Common Structural Rules for Bulk Carriers and Oil Tankers

Technical Background for Urgent Rule Change Notice 1 to 01 JAN 2015 version

Rule Change Notice

Figure 1:

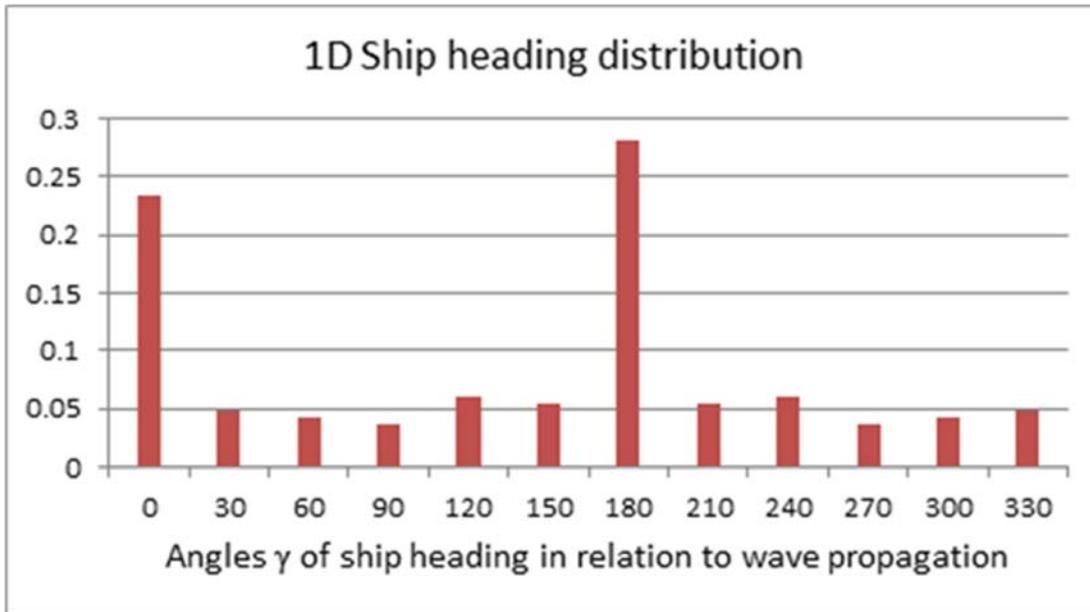
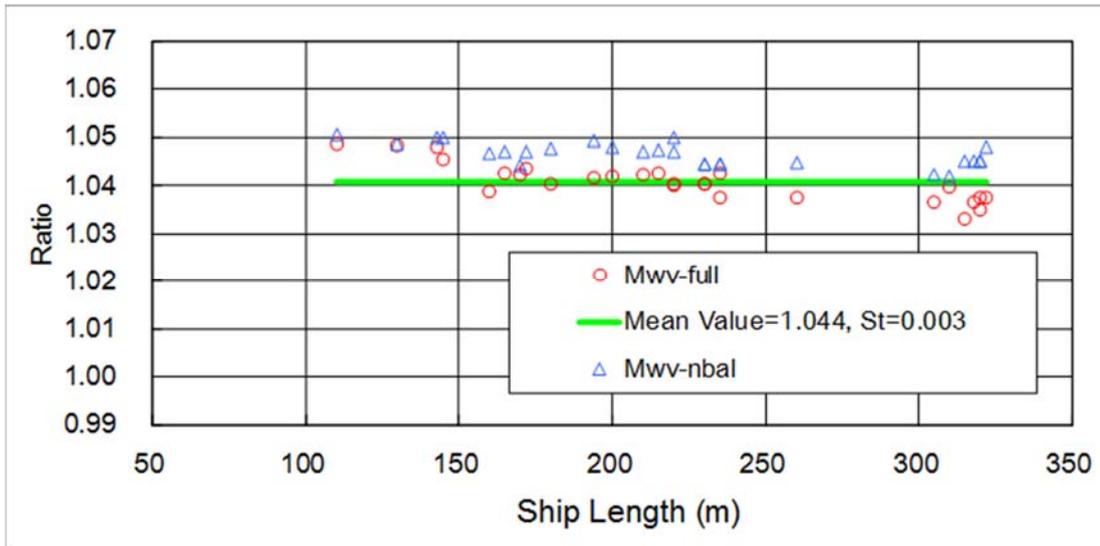
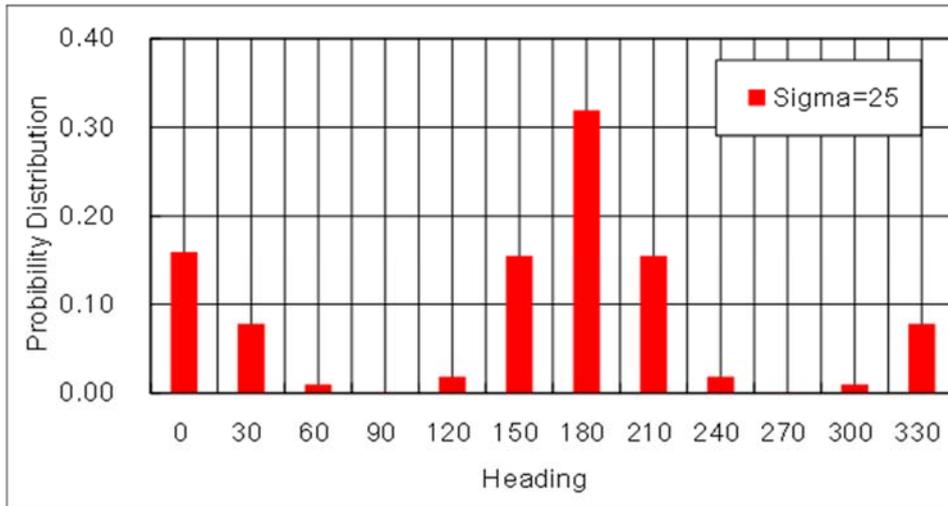
The development of non-uniform ship heading distributions based on the sensitivity analysis is presented in Technical Background report [5]. The examples of the developed ship heading distributions based on different approaches are presented in Figure 1 and Figure 2, which come directly from the Technical Background report [5].

Lack of field data does not allow a decision as to which of the assumption is the most accurate. Nevertheless, the impact on the M_{wv} and Q_{wv} for different ship heading distributions is quite similar, and does not exceed 5%.

Based on the computations of $M_{wv}(non-uniform)/M_{wv}(uniform)$, the heading correction factor f_{β} (Pt1 Ch. 4 Sec 4) was thus set on the conservative level: $f_{\beta} = 1.05$ for HSM and FSM in the extreme sea loads design scenario.

The 1D non-uniform ship heading distribution yields greater results for M_{wv} , Q_{wv} than the 1D uniform distribution (the uniform distribution is optimistic). For other responses, such as for example M_{wh} (horizontal bending moment), M_{wt} (wave torsional moment), p (dynamic pressure), this relationship is reversed (the uniform distribution is conservative).

Therefore heading correction factor $f_{\beta} = 1.05$ for HSM and FSM load cases for the extreme sea loads design load scenario was offered as the Rules Change Notice.
